Staff Report to the Appearance Commission for PC 25-06  
Prepared by Brandon Nolin, AICP, Community Development Administrator  
Dated May 27, 2025

Re: Appearance Commission Case AC 25-08  
Request for approval of an Appearance Certificate for site, landscape, and building plans associated with Case PC 25-06, a request for a Special Use Permit for redevelopment to establish warehousing, distribution centers, and light manufacturing uses at the properties commonly known as 8125-45 River Drive and 8120-40 Lehigh Avenue, Morton Grove, Illinois (PIN 10-20-303-001-000; 10-20-303-002-000), all within M-O/R Office/Research Manufacturing District per Section 12-4-4:E, with select waivers regarding setbacks, landscaping, signage, and parking located in a street side yard per Sections 12-2-6 and 12-4-4 and Chapters 10-10 and 12-11; and approval of a Preliminary and Final Plat of Subdivision in accordance with Chapter 12-8. The applicant is Midwest RE Acquisitions, LLC which is an entity of Bridge Industrial.

Plan Review Comment Forms for PC 25-06,  
prepared by Traffic Safety Commission Chairman Amit Shah (dated June 9, 2025)  
and Traffic Safety Commission Chairman Ninous Chalabi (dated Ma

### **Materials**

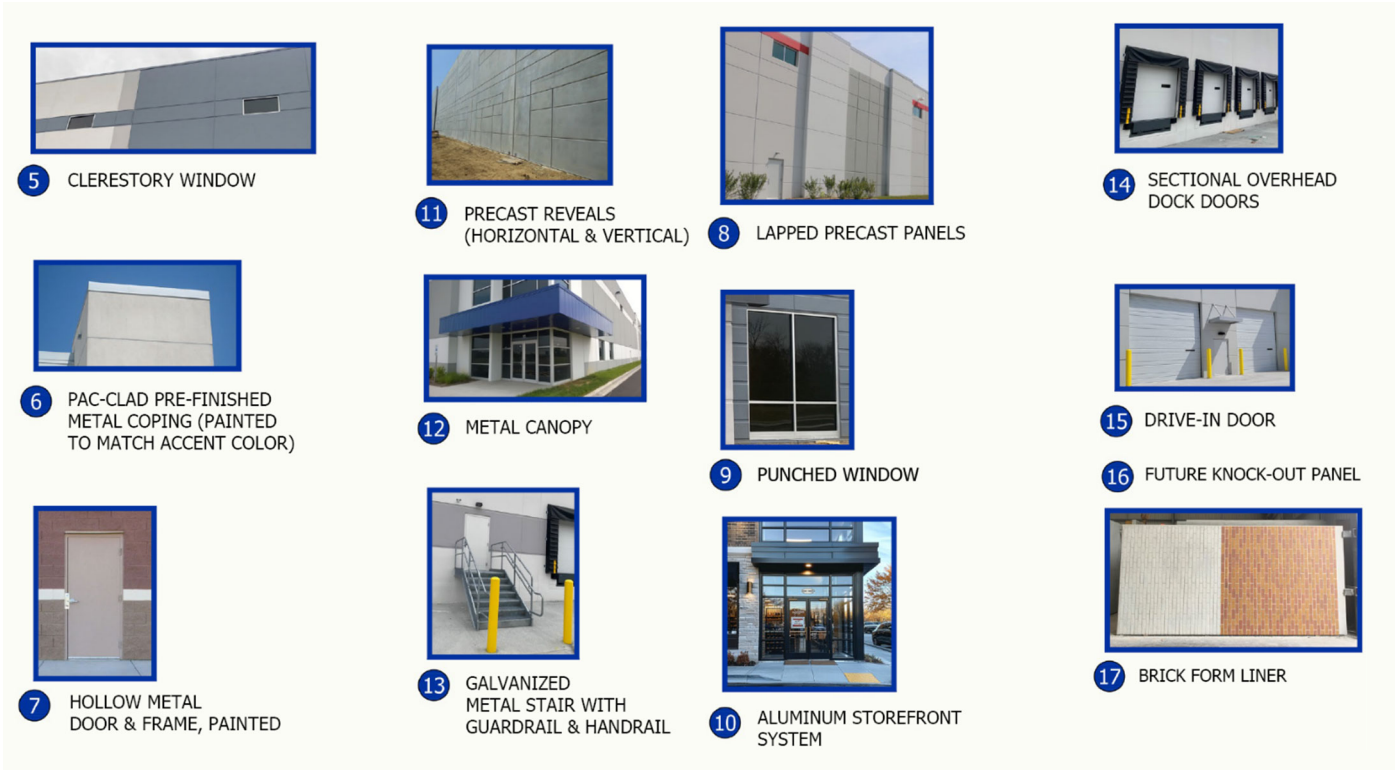
Rooftop mechanicals were not included in the application materials and Staff recommend requiring screening of mechanicals as a condition of approval unless the applicant and provide sufficient information regarding limitations to sight lines from surrounding rights-of-way. ***The applicant should speak to the anticipated location of rooftop mechanicals and the potential need for screening.***

**Tree Preservation**

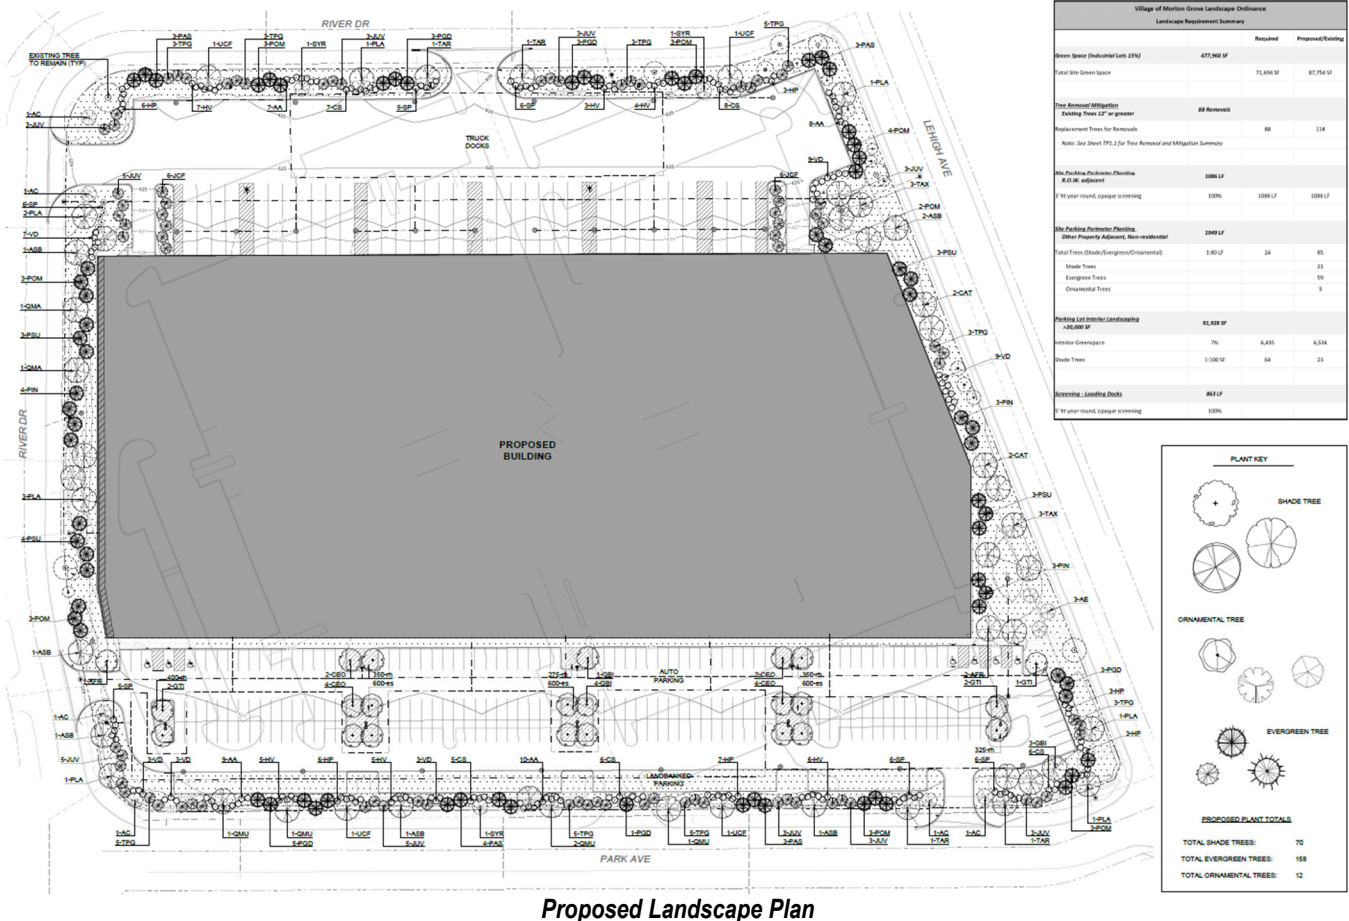
A tree survey submitted by the applicant identifies 128 existing trees on the subject property, 34 of which are considered to be protected trees which are non-nuisance species with a diameter at breast height of 12 inches or greater per the Village's recently approved Tree Ordinance (Ord. 24-28). The landscape plan proposes the preservation of 19 of the 128 existing trees including preserving one (1) protected tree. As such, a total of 33 replacement trees are required to be identified. The applicant has identified 27 shade trees and 87 evergreen trees for a total of 114 replacement trees that will meet Village requirements.

**Parking Lot and Entrance Lighting**

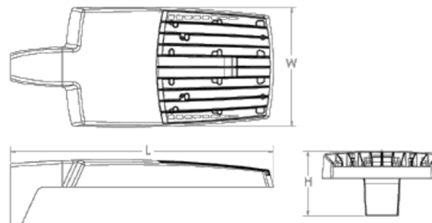
Per Section 12-4-3:B.5, the lighting of parking and loading areas shall be a minimum of one foot-candle on the surface. Per the submitted photometric plan, many of the parking stalls located between parking lot islands would have light levels of less than one foot-candle (1 ft-c). The building entrances also generally have low light levels. While lighting at the central entrance exceeds 1 ft-c, lighting at the west and east entrances ranges between 0.5 and 0.8 ft-c. **The applicant should speak to the types of lighting fixtures proposed in the photometric plan and address concerns regarding sufficient safety lighting.**

**Proposed Monument Sign Size (Left) and Location (Right – Labeled '1')**

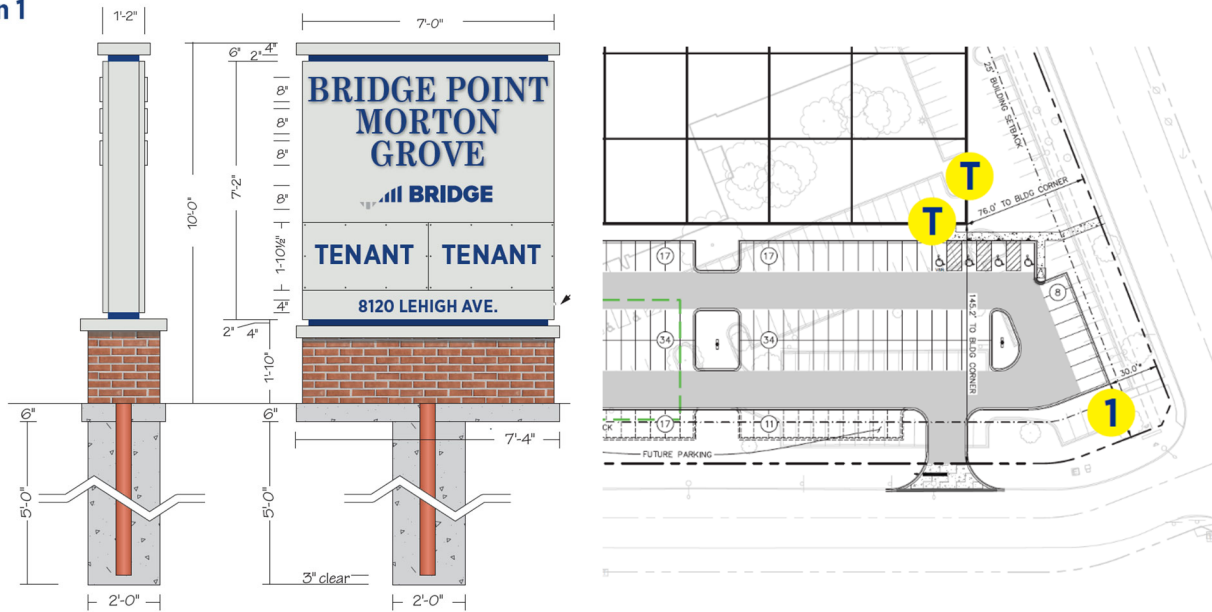
The proposed monument sign would be ten feet (10') tall with a sign area of 50.2 sq. ft. The proposed sign is required to be located at least five feet (5') from the public right of way along Park Avenue and Lehigh Avenue. The sign plan does not provide the precise location of the proposed monument sign, but there appears to be sufficient space for a compliant sign location given that the parking lot is located 30 feet (30') from either right of way. A landscape bed extending two feet (2') from the sign base is required, but not provided for in the sign plan. **The applicant should speak to the proposed sign location, proposed landscaping, and confirm whether related waivers are requested.**

**Proposed Address Sign**

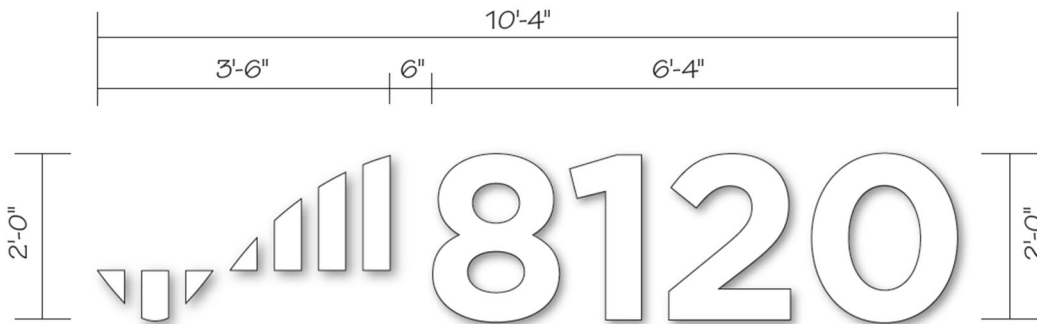
The address sign would consist of a Bridge Development logo and street number and would be 20.7 sq. ft. The address sign would be constructed of one inch (1") thick acrylic that is painted white and flush mounted to the building. The proposed sign is in excess of the two (2) sq. ft. maximum permitted, however Staff note that the sign size is proportional to the building and are not concerned with the request. Similarly sized address numbers are located on other industrial buildings in the area and the Bridge Development logo measures seven (7) sq. ft. which is smaller than tenant signage typically permitted.
